Service bulletin

THE BRITISH MOTOR CORPORATION (AUSTRALIA) PTY. LIMITED

SCREWS FOR CENTRE SUPPORT AND PLUG ASSEMBLY

BORG-WARNER
AUTOMATIC
TRANSMISSION
MODEL 35

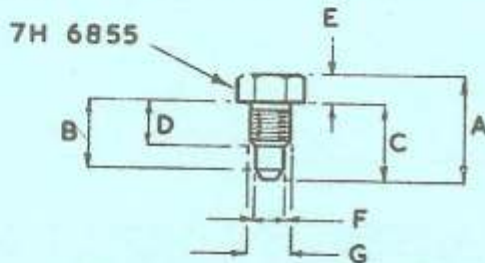
A number of vehicles have transmissions with one of the holes 'X' in the centre support machined $3/32$ " shallow. This has necessitated the shortening of the corresponding screw by approximately the same amount. With some units both screws have been shortened.

In cases of repair to these transmissions, mark the screws and bosses to ensure correct reassembly of the screws. If this is not done, bottoming and damage to the screw boss may occur.

Where both holes are at the standard reamed depth of 15/64" the foregoing obviously does not apply.

NOTE: Only standard length centre support screws 7H 6855 as illustrated below are available. Where a new short screw is required this will entail shortening of the standard item.
